DOCUMENT 00 90 00
ADDENDUM

ADDENDUM No.: 3

RE: LAC DU FLAMBEAU CHILD DAYCARE CENTER
ADJACENT TO 13708 YOUTH CTR LN (TO THE SOUTH)
LAC DU FLAMBEAU, WISCONSIN 54538
PROJECT NO. 22066

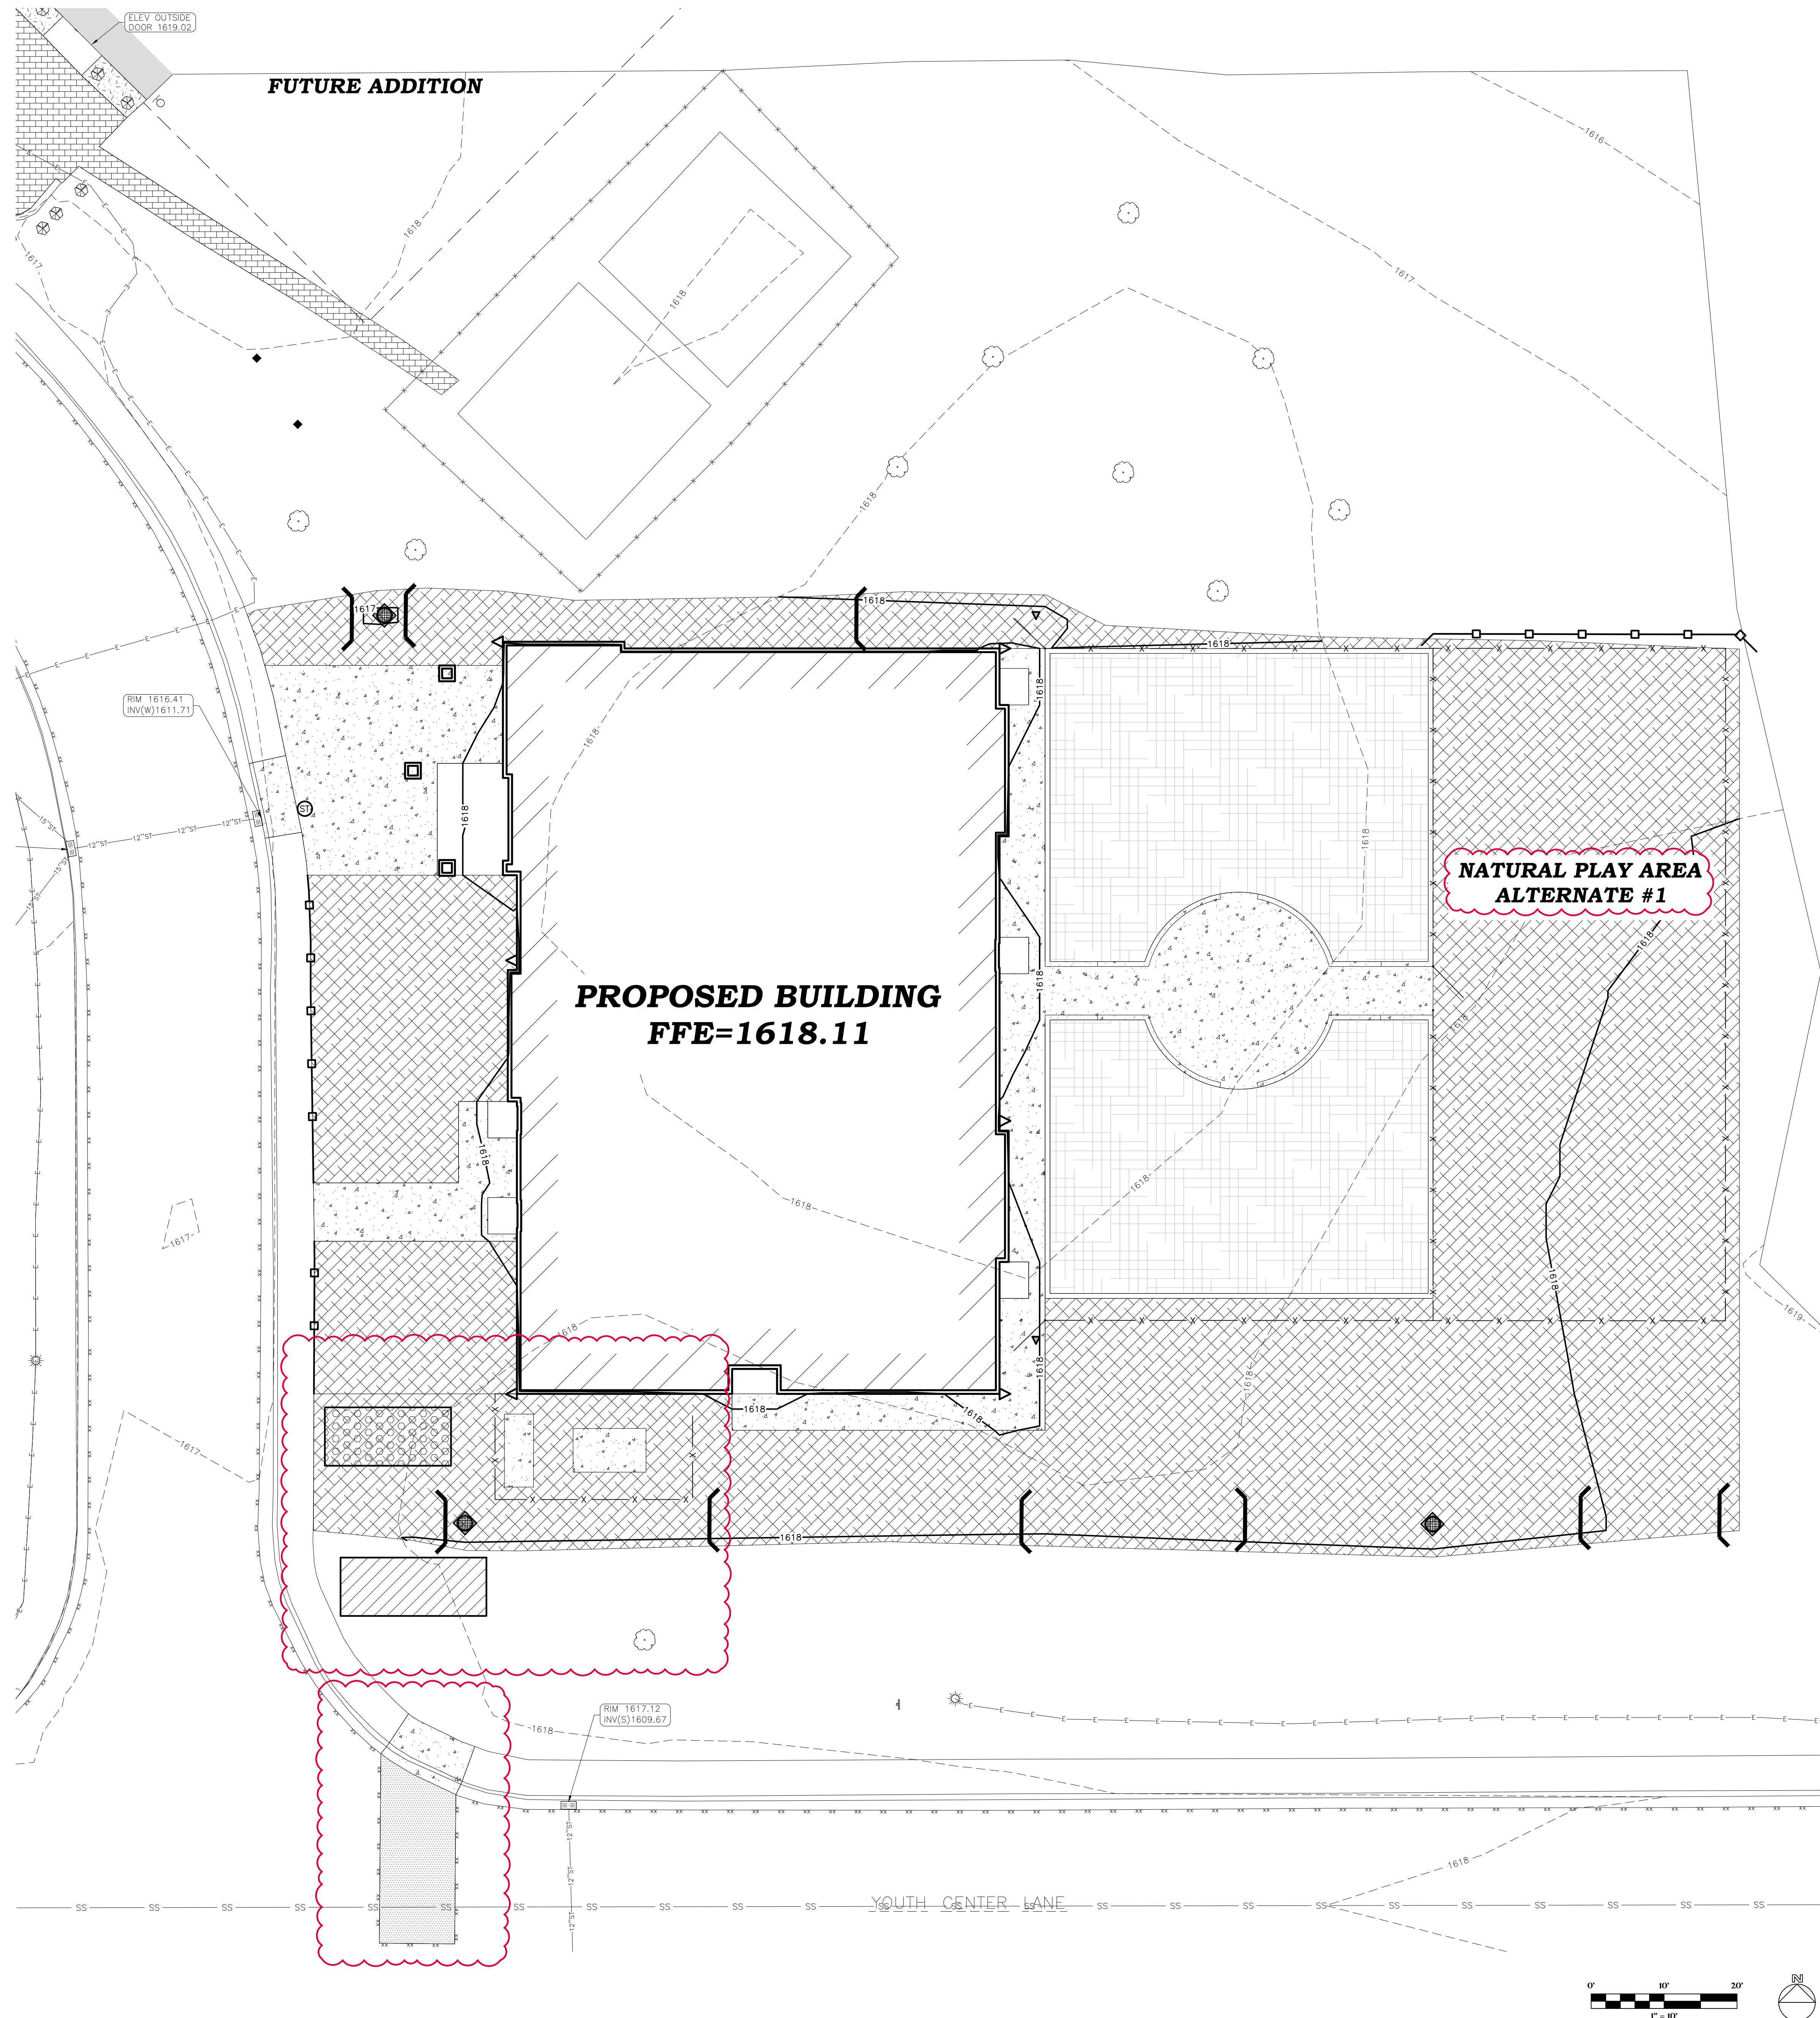
- b. Added label for "Natural play area alternate #1".
 - c. Revised elevations at added concrete pad and added elevations at paving.
7. Sheet C103 EROSION CONTROL PLAN 30"x42"

- a. See the revised sheet included in this addendum. Disregard the previous version.
 - b. Added label for "Natural play area alternate #1".
 - c. Revised locations of erosion control items.

- d. Showed areas of paving replacement.
8. Sheet C104 UTILITY PLAN 30"x42"
 - a. See the revised sheet included in this addendum. Disregard the previous version.

C104

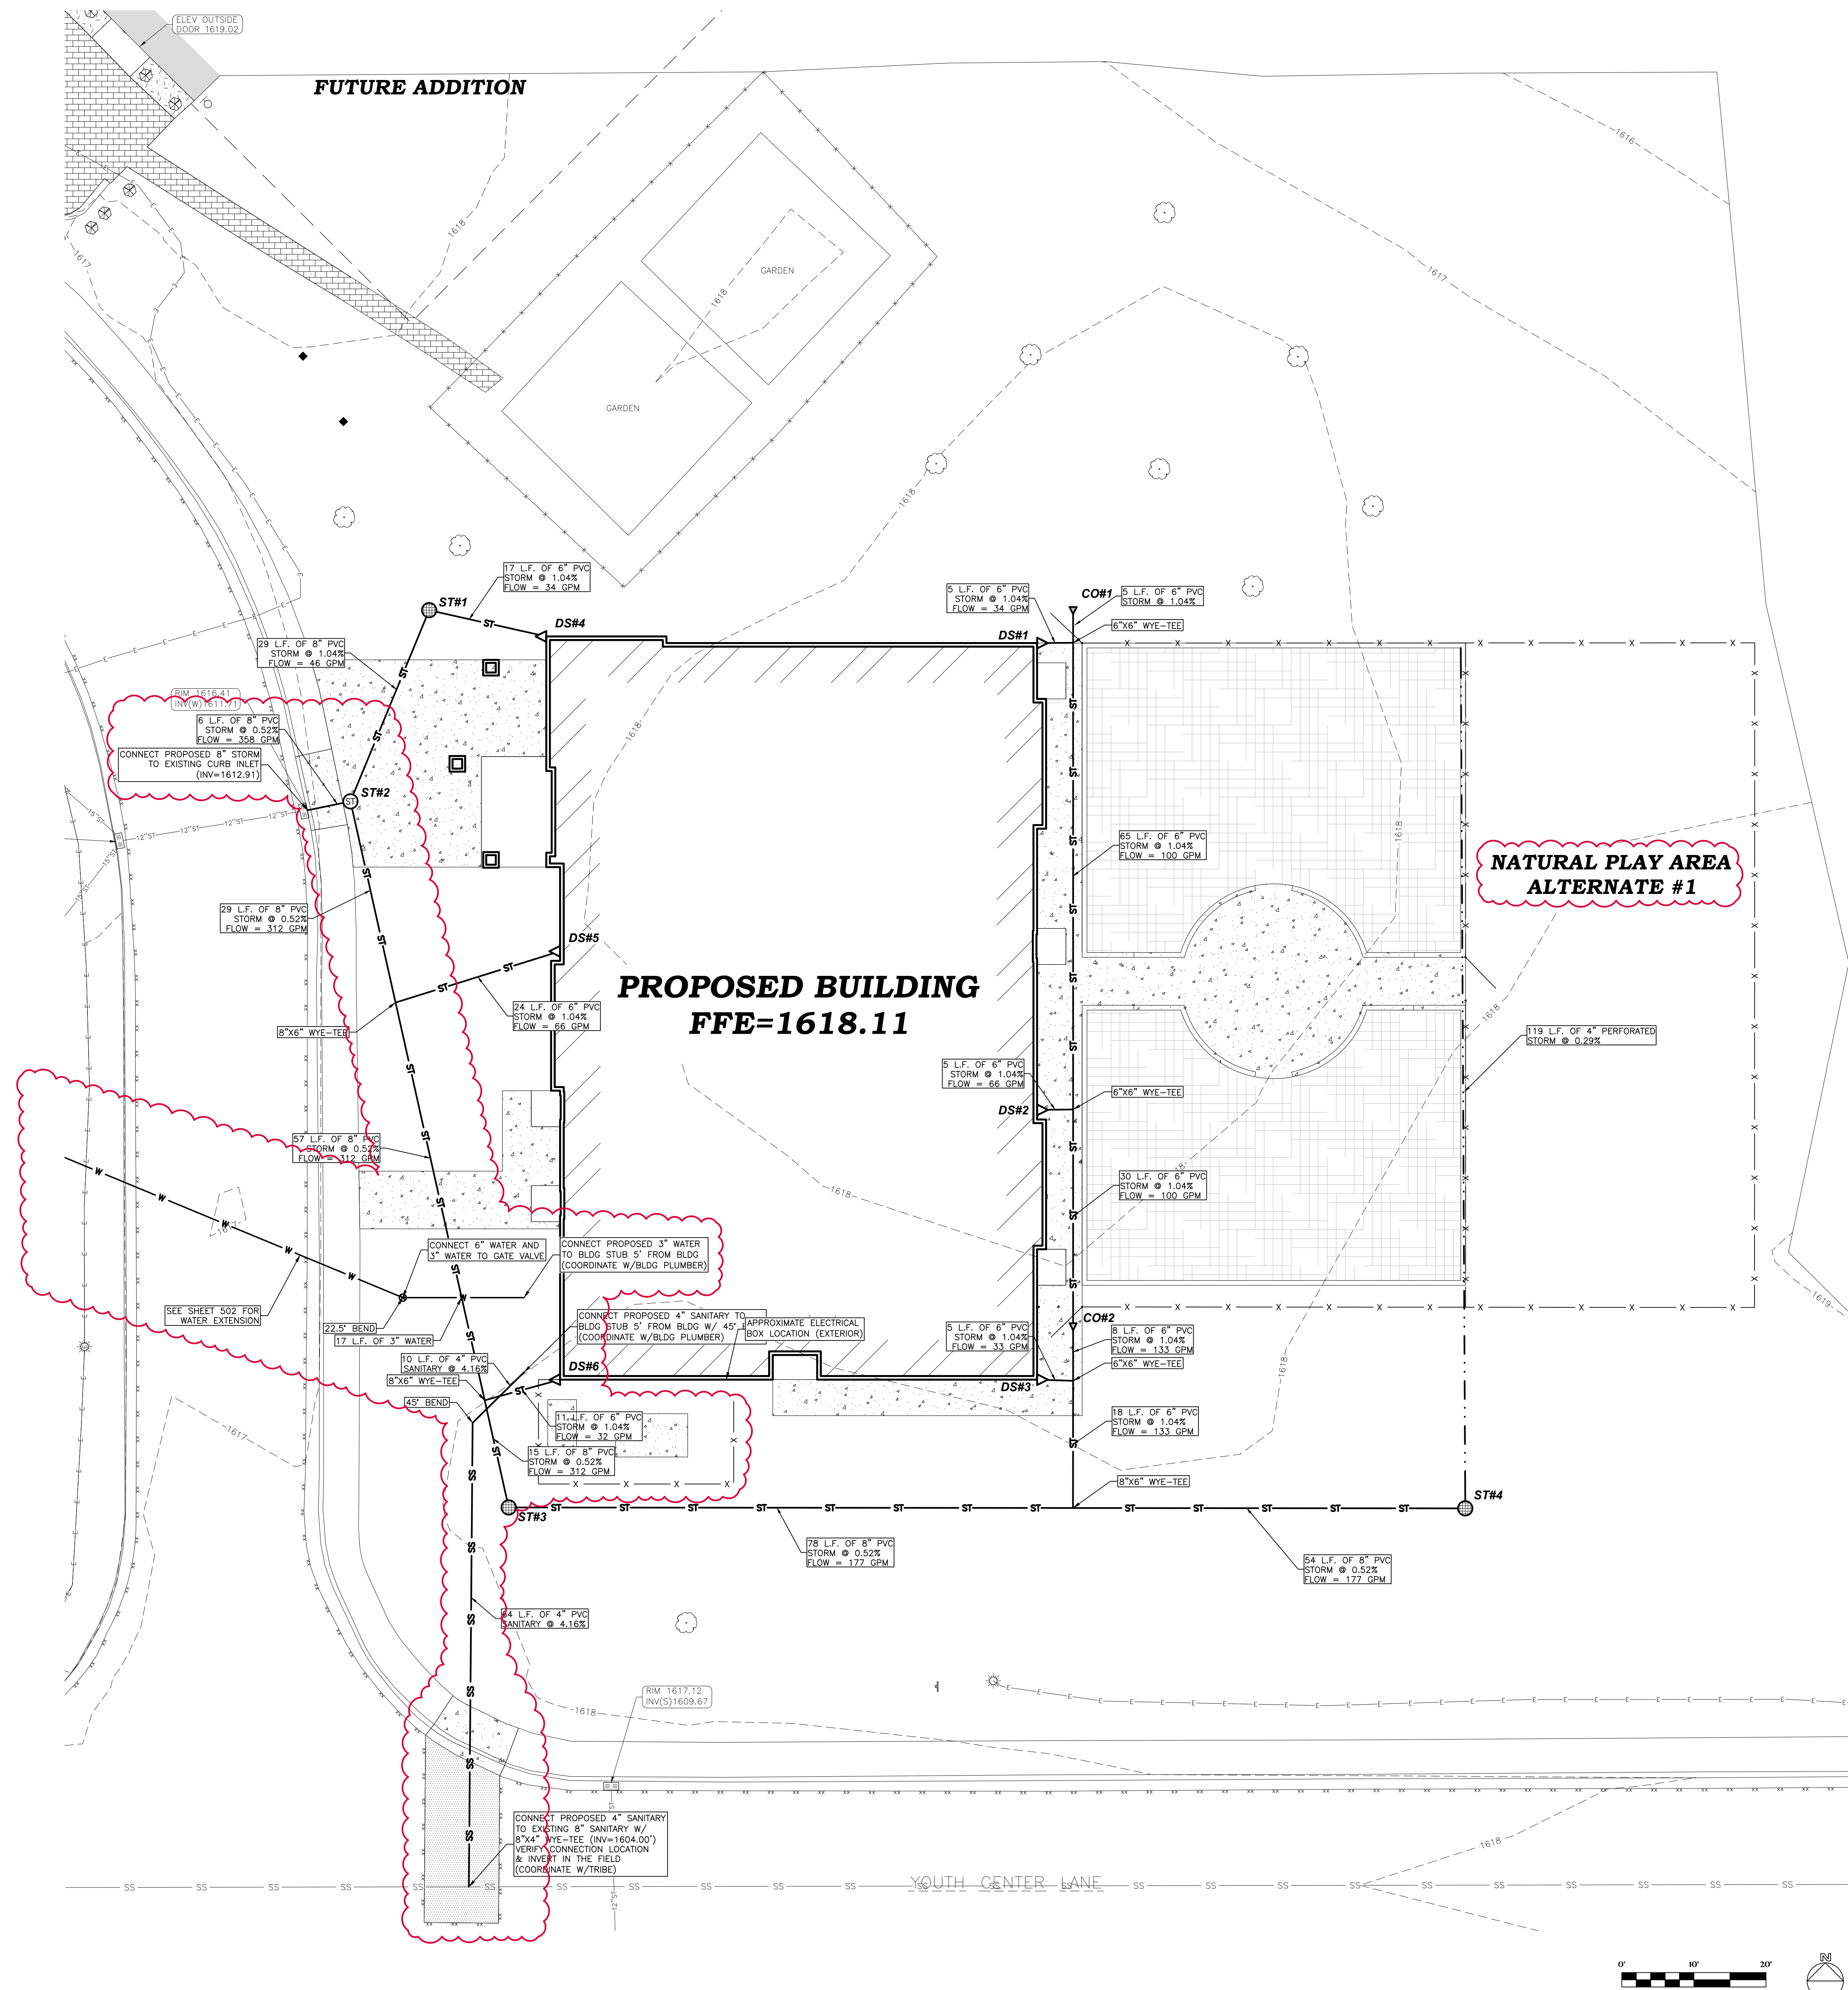
- b. Added label for "Natural play area alternate #1".
 - c. Revised storm sewer, water, and sanitary sewer.
9. Sheet C105 WATER PLAN 30"x42"
 - a. See the new sheet included in this addendum.

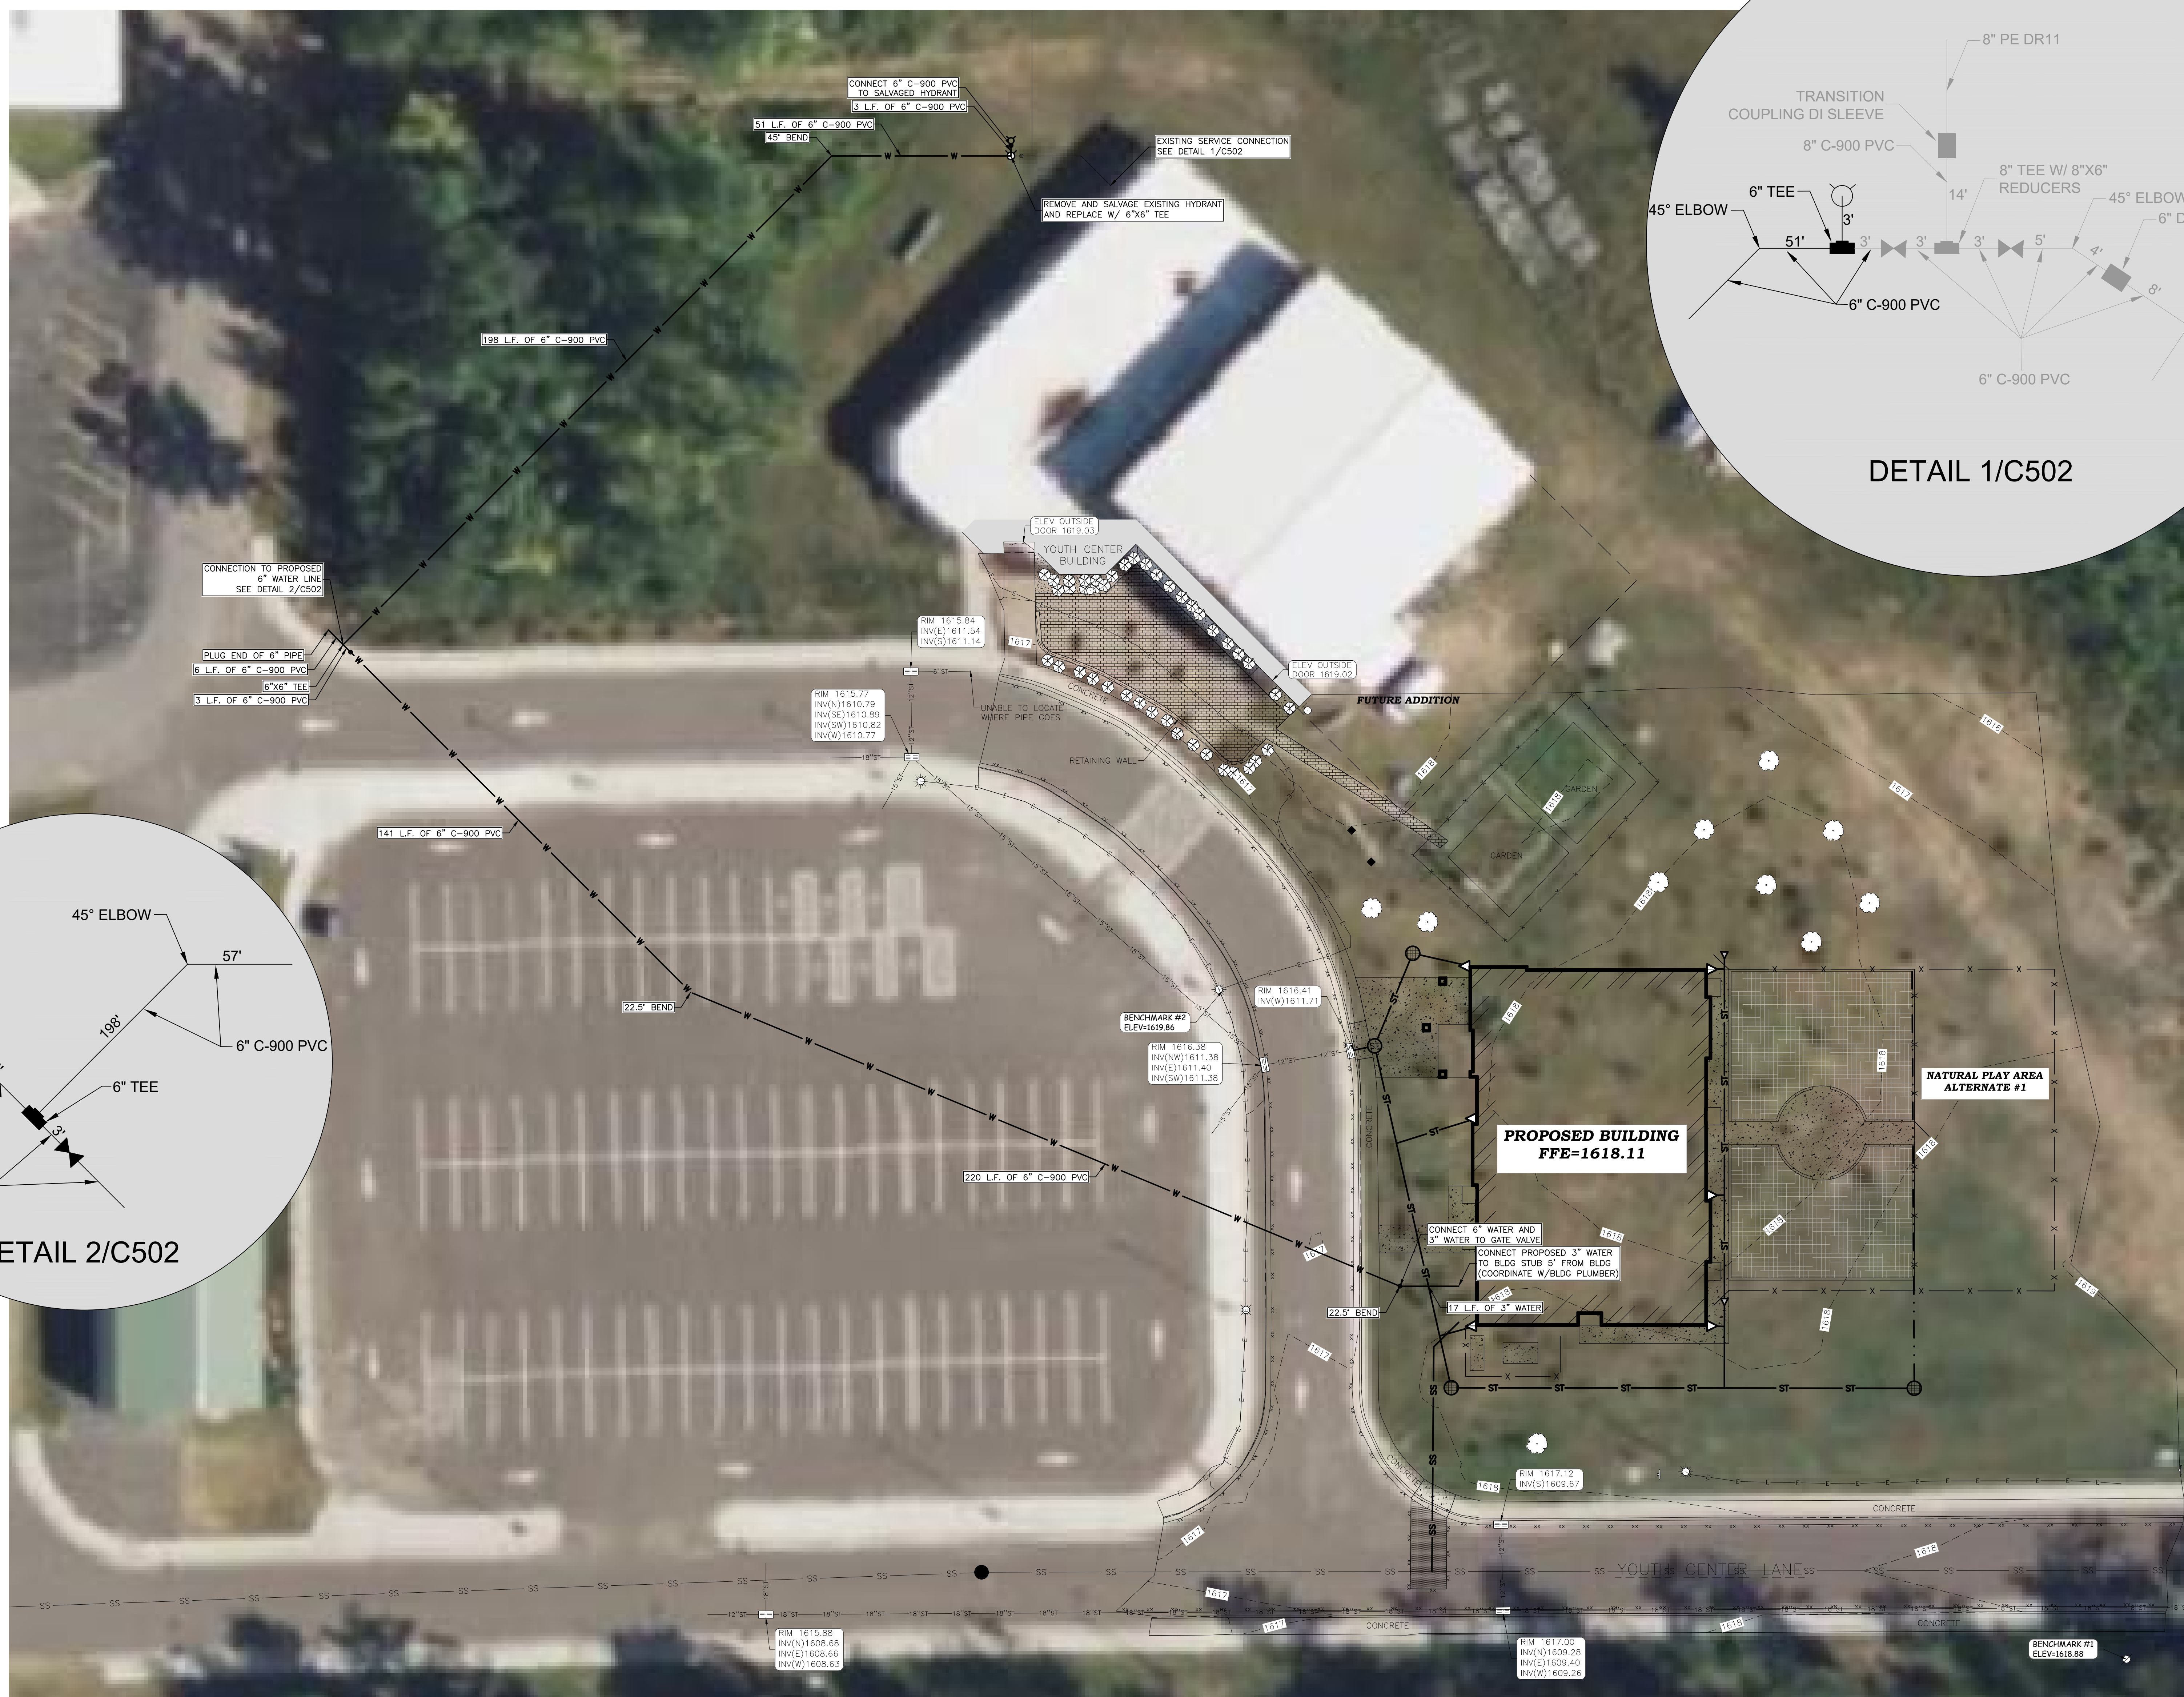
- b. Sheet shows the extension and modification of water supply piping.
10. Sheet C106 DETAILS 30"x42"
 - a. See the revised sheet included in this addendum. Disregard the previous version.
